2016 MANAWATU AIRSPACE REVIEW

**Airways New Zealand submission to the
Civil Aviation Authority's
2016 Manawatu Airspace Review**

Submission to 2016 Manawatu Airspace Review

Massey University School of Aviation submission

WANGANUI RNAV RWY 29

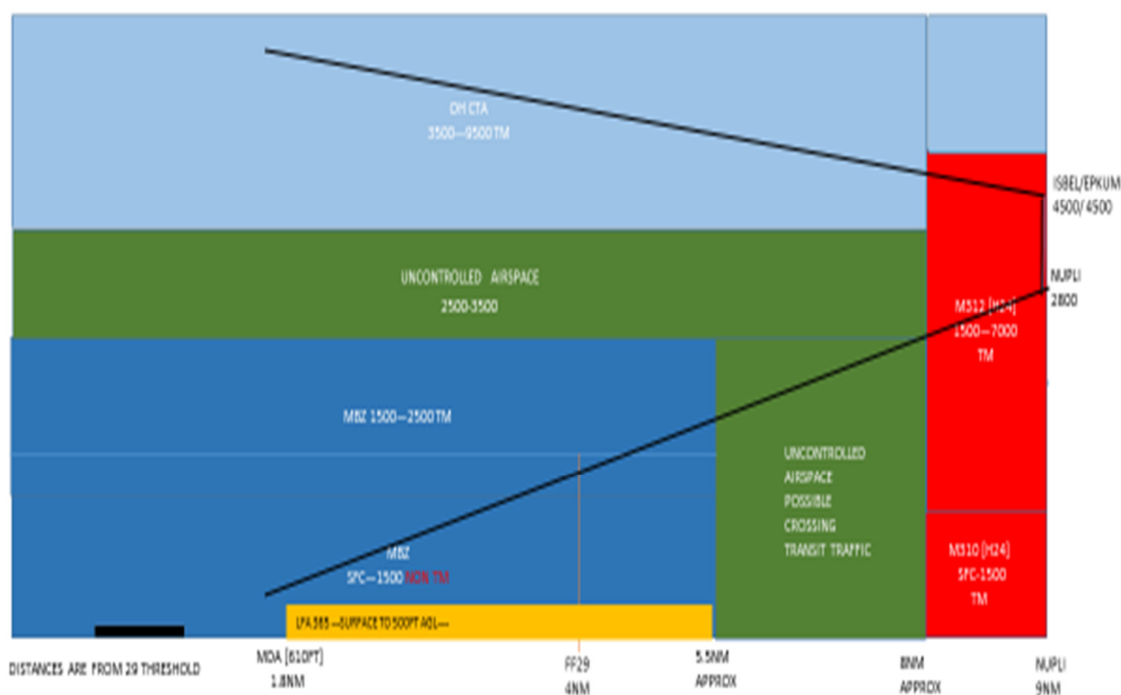
- The proposed MBZ extension does not, in our opinion, extend far enough to the South. There is still a gap of no man`s land between the MBZ and OH airspace. Anyone conducting the RNAV 29 approach must transit this area.[refer below] Our thoughts are that the MBZ should be extended further South to meet up with the OH boundary. This would eliminate the no man`s land encountered on the RNAV 29 approach. Exactly the same rational as raising the MBZ to eliminate the gap between the MBZs upper level and controlled airspace.
- To enhance Crew situational awareness, particularly when conducting an instrument approach and transitioning to visual conditions, we strongly advocate that all MBZs be designated as transponder mandatory [TM] from the surface to the upper limit of the MBZ

Retention of B680 Paraparaumu MBZ Transponder Mandatory Lower Limit

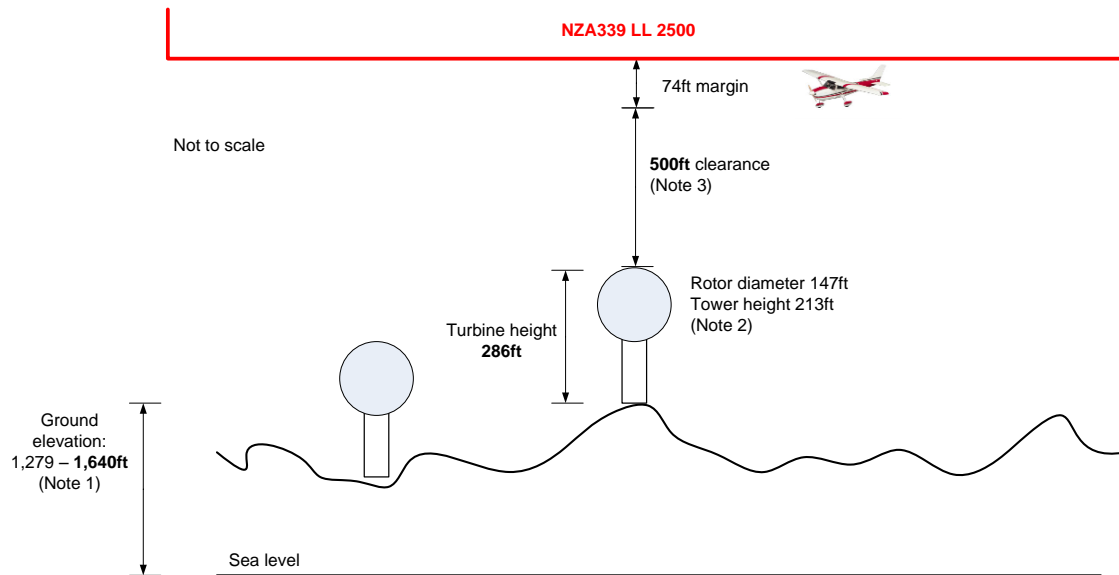
Submission: The lower limit of the transponder mandatory area within the B680 MBZ remains at 1500'.

Justification: As Performance Based Navigation (PBN) procedures are progressively introduced throughout New Zealand the prevalence of transponder mandatory areas is likely to increase. When reviewing the B680 MBZ consideration should be given to:

In consideration of the above we believe there is insufficient justification to lower the existing 1500' boundary of the transponder mandatory area of the B680 MBZ.

NZA339 Lower Limit

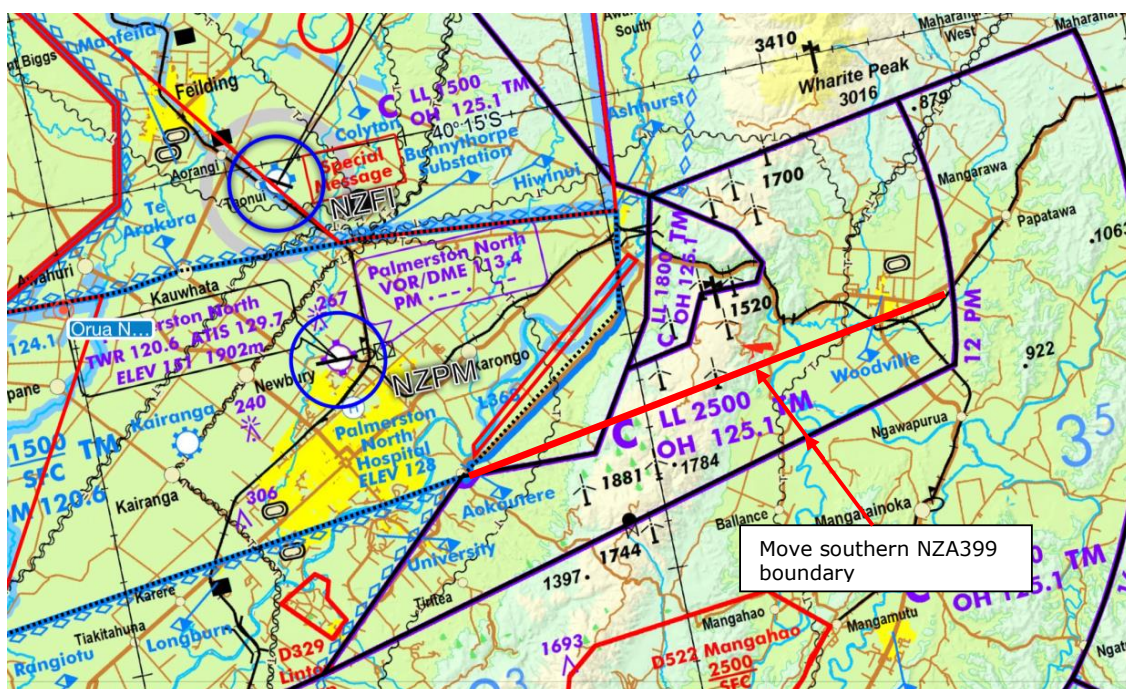
Submission: Reduce the size of CTA-C NZA339 east of Palmerston North and above the Tararua Wind Farm.

Justification: The area to the south of the Manawatu Gorge is a common transit area for aircraft crossing between the Manawatu and Hawkes Bay / Wairarapa. VFR aircraft are constrained laterally to a 6nm area north of the radar dome and south of the Manawatu Gorge and vertically by the 500' clearance above the wind turbines and lower boundary of NZA339. As depicted in the following diagram if the controlled airspace is to be avoided and CAR 91.311(a)(2)(ii) is adhered to an area 6nm x 74ft must be navigated that is outside the Manawatu CFZ, is frequently turbulent and with a reasonable chance opposing traffic may be encountered.

With the introduction of Controlled VFR transit fees by Airways, VFR pilots are reluctant to enter controlled airspace. In the spirit of reducing the prevalence of controlled airspace (which we understand to be an Airways objective), we recommend the southern boundary of NZA399 is moved north so that it runs approximately from the Aokautere to the Woodville VFR reporting points as shown below. This would avoid unintentional infringements of the lower boundary of NZA339 and will provide a greater margin of vertical safety as aircraft crossing the Tararua Wind Farm can fly at a height of up to 3500' outside of controlled airspace and well to the south of the Palmerston North 07/25 extended centreline.

Figure 1 – Rangitikei CFZ

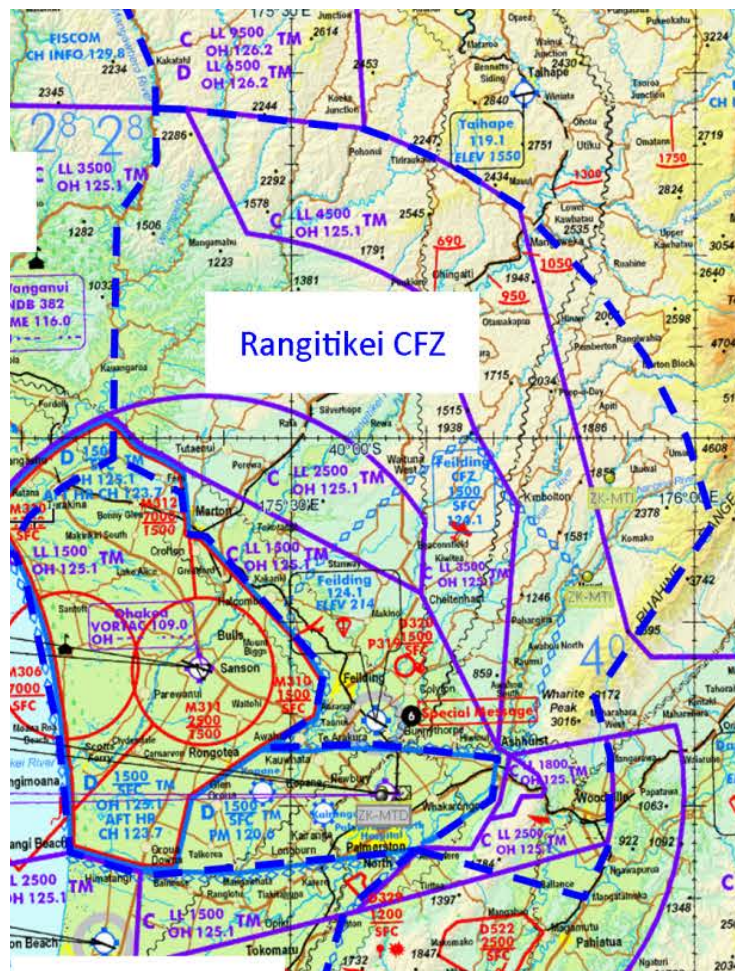
2. Increase the size, upper limit and name of NZC376 (Feilding CFZ). This larger area (see figure 1) will ensure that VFR traffic confined between military airspace to the west and terrain to the east have a safe area for aircraft to aircraft communication. The current size of the CFZ does not allow traffic transiting north or south sufficient space to allow for the busy VFR training areas, or allow for traffic transiting to or from Wanganui Aerodrome. The upper limit of this CFZ should be raised from 1500 feet AMSL to the lower limit of controlled airspace. Re-naming the CFZ will allow for "Feilding Traffic" to relate only to the traffic operating in the vicinity of Feilding Aerodrome, and not the entire area. Extending the CFZ to encompass the Manawatu Gorge area will be essential to increasing safety for VFR transiting through the tight corridor.

3. Reduce size of M310 and M312 to allow for IFR operations at Wanganui to be contained outside of military airspace and also allow a safer transiting area for VFR traffic tracking to or from Wanganui (see figure 2). Reducing the western boundary (arc) of M310 / M312 to the vicinity of the Turakina River will allow for the NUPLI hold and RNAV 29 approach to be contained entirely outside of the military airspace. Reducing the eastern boundary north of Marton by 1.0 NM will allow for VFR traffic to track via the high tension power lines without

infringing military airspace. The current VFR advisory route specifies 1000 feet at the northern end which is below 500 feet AGL. The proposed change of the eastern boundary will allow VFR traffic tracking north to fly on one side of the power lines, and traffic tracking south on the other.

- 4. Establish CFZ at Wanganui (see figure 3) to ensure arriving and departing IFR traffic has adequate time / space to coordinate with VFR traffic in the area. Currently the DUDED hold on the RNAV 11 approach extends into the Taranaki CFZ. The Taranaki CFZ should be reduced and the new CFZ / MBZ extended to the vicinity of Waiinu Beach.
